Project	IEEE 802.16 Broadband Wireless Access Working Group < http://ieee802.org/16 >		
Title	Remedy for the procedure of MRS handover		
Date Submitted	2008-03-15		
Source(s)	Yanling Lu, Sunil Vadgama Masato Okuda Fujitsu	E-mail:	yanling.lu@uk.fujitsu.com
Re:	IEEE 802.16-08/007 "IEEE 802.16 Working Group Letter Ballot Recirc#28b: Announcement"		
Abstract	This contribution proposes to remedy for the procedure of MRS handover with preamble changed (Inter MR-BS).		
Purpose	Text proposal for 802.16j Draft Document.		
Notice	<i>This document does not represent the agreed views of the IEEE 802.16 Working Group or any of its subgroups. It represents only the views of the participants listed in the "Source(s)" field above. It is offered as a basis for discussion. It is not binding on the contributor(s), who reserve(s) the right to add, amend or withdraw material contained herein.</i>		
Release	The contributor grants a free, irrevocable license to the IEEE to incorporate material contained in this contribution, and any modifications thereof, in the creation of an IEEE Standards publication; to copyright in the IEEE's name any IEEE Standards publication even though it may include portions of

Figure 2 The problem when MRS performs handover with access-link channel characteristics changed

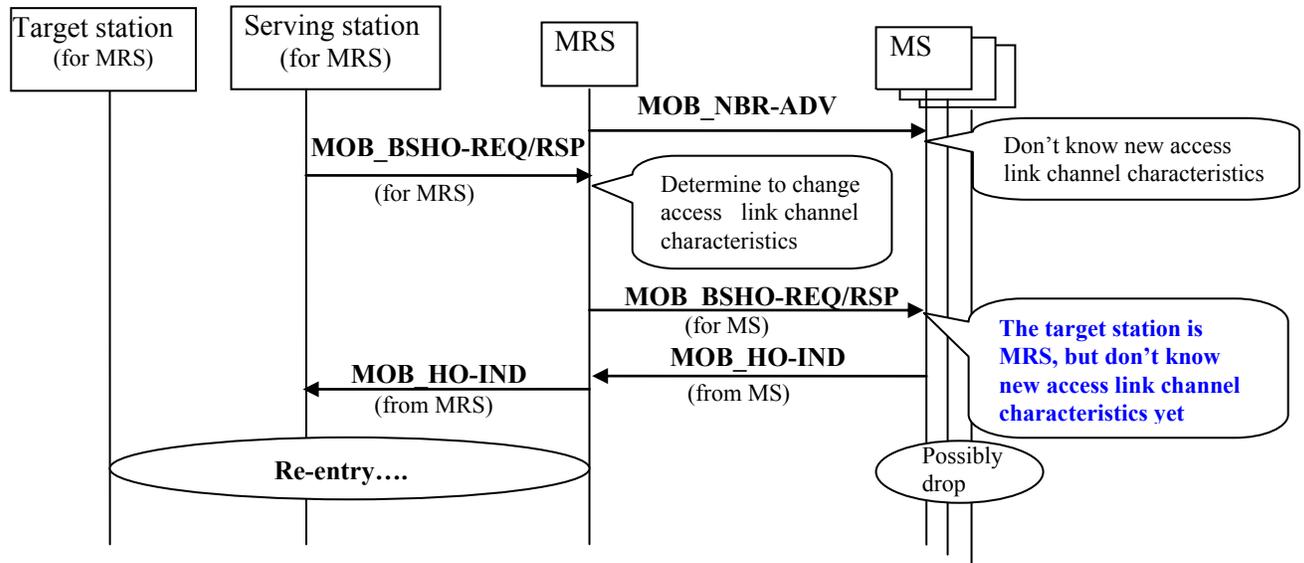
Now consider a situation of Mobile Relay Station (MRS), as defined in IEEE802.16j, located on a vehicle (eg: bus or a train). In some cases, when the MRS handovers from one station to another, it needs to change FA, DCD/UCD or some other access link channel characteristics. However, before the MRS conducts handover, even MRS itself doesn't know its new access link channel information (because it doesn't know its target serving station). Any MOB_NBR-ADV received by MS before the MRS handover procedure associates the MRS to its current access link channel characteristics and not to the new access link channel characteristics. However, without receiving the neighbor station information from MOB_NBR-ADV, MS should take more time to perform re-entry procedure and drop with high possibility even if it receives BSID/Preamble index in MOB_BSHO-REQ/RSP(See figure 2). For example, without FA information, the MS should scan the former frequency of MRS firstly and is doomed to fail. Then the MS may scan other neighbour stations' frequency or

other possible channels of the downlink frequency band of operation until it finds a valid downlink signal. Another example is: Without DCD/UCD information, the MS needs monitor the DCD/UCD broadcasted by the MRS after MRS handover in order to synchronize with MRS.

Figure 3 The Proposed Solution (in the case of MRS inter MR-BS handover)

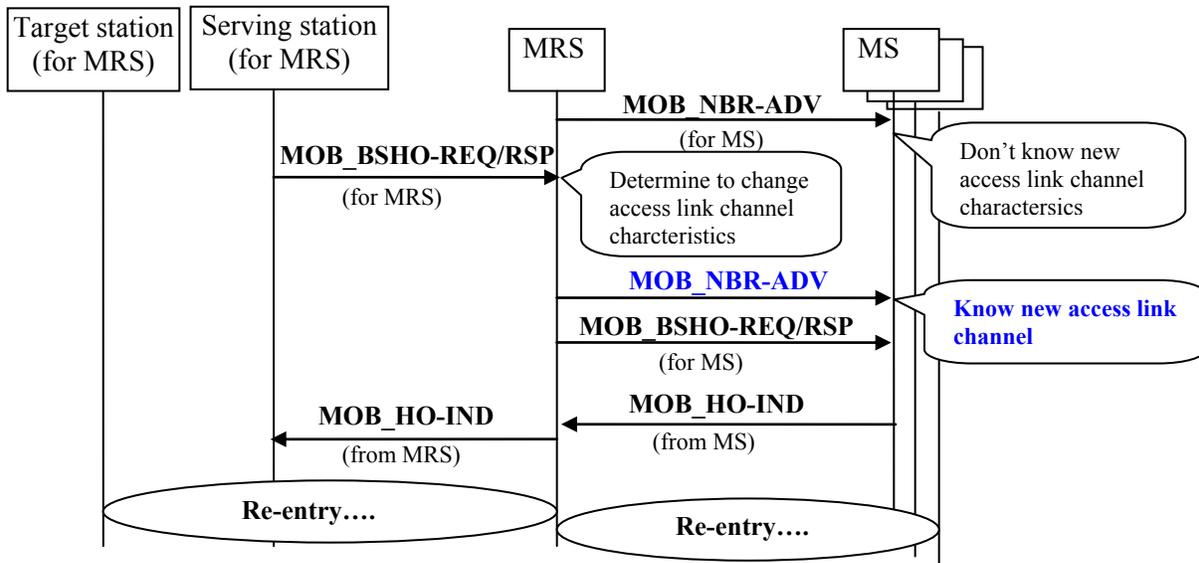
The following procedure is proposed for solving the above problem(See figure 3):

When the target access link channel characteristics of MRS is determined, the MRS may originate the MOB_NBR-ADV according to MOB_NBR-INFO, MOB_BSHO-REQ/REP and information itself contains. Before the MRS sends MOB_BSHO-REQ/RSP to MSs, it should broadcast MOB_NBR-ADV message to inform the MSs of the MRS's new access link channel characteristics, such as FA, DCD/UCD and so on, if needed. The MRS itself should be included in the neighbour station list with IEs set corresponding to the new access link channel characteristics. This MOB_NBR-ADV message is not a periodic broadcast and precedes the MSs' handover procedure. After sending non-periodic MOB_NBR-ADV message, MRS can initiate the MS' handover procedure or respond to the MS's handover request. In the following MOB_BSHO-REQ/RSP messages, the MRS itself should be included in the neighbour station list with the IEs set according to the new access link channel characteristics.
